UNITED STATES PATENT AND TRADEMARK OFFICE

APPLICATION NO.	FILING DATE	FIRST NAMED INVENTOR	ATTORNEY DOCKET NO.	CONFIRMATION NO.
09/732,129	12/06/2000	John A. Pacey	1116-008/JRD	9598

Office Action Summary

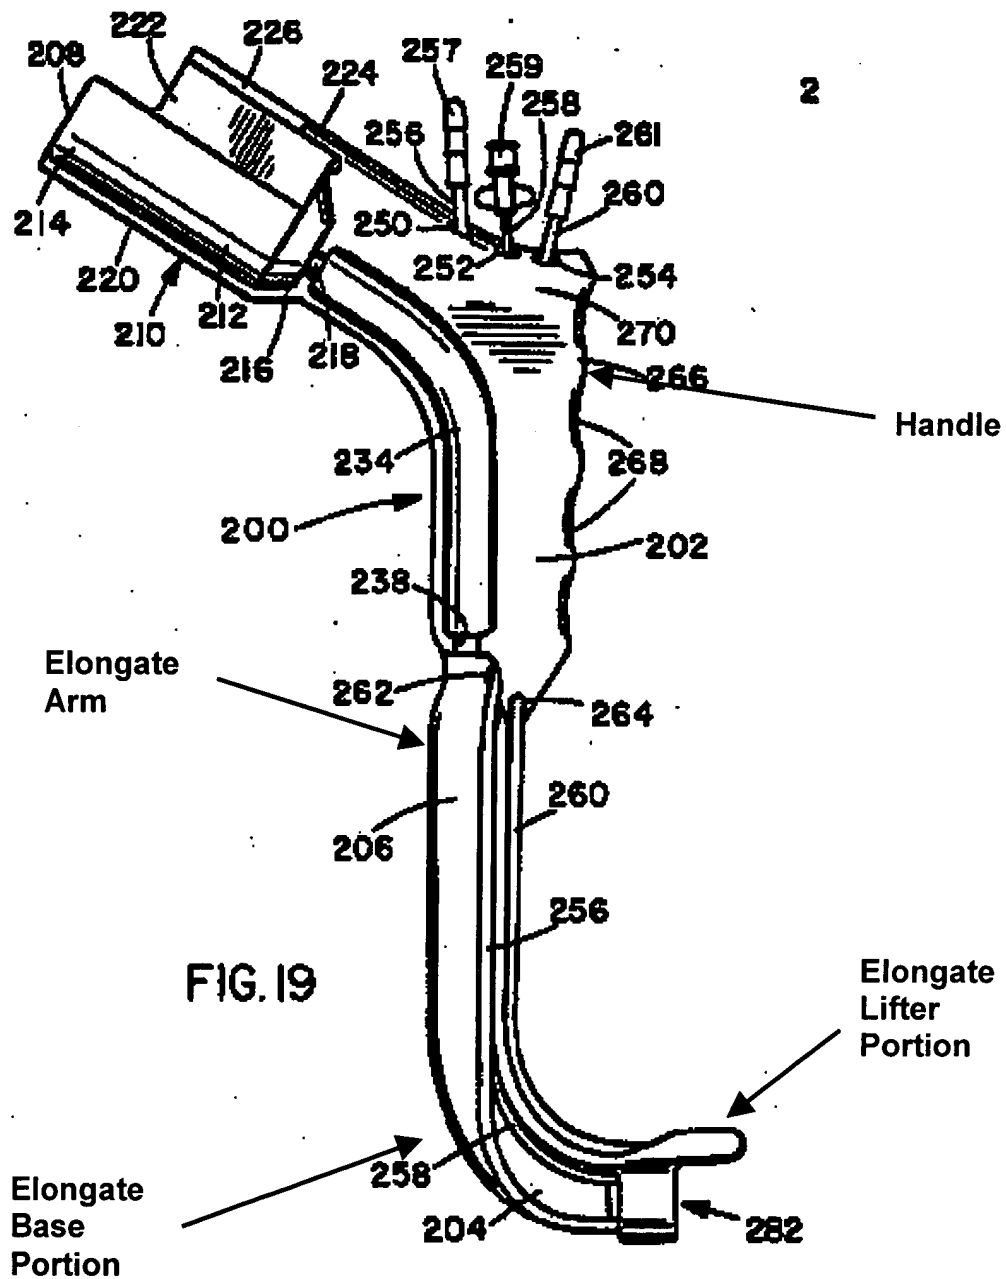
Augustine in an intubation instrument discloses:

- a body (see Fig. 23 illustrated below) having a handle (200, 266) attached thereto;
- an elongate arm (see Fig. 23, illustrated below) having an elongate base portion attached to the body and,
- an elongate lifter (Fig. 23, below) said lifter portion being at least 3 centimeters long and extending from said base portion by at least a 5 degree angle (Fig. 23)
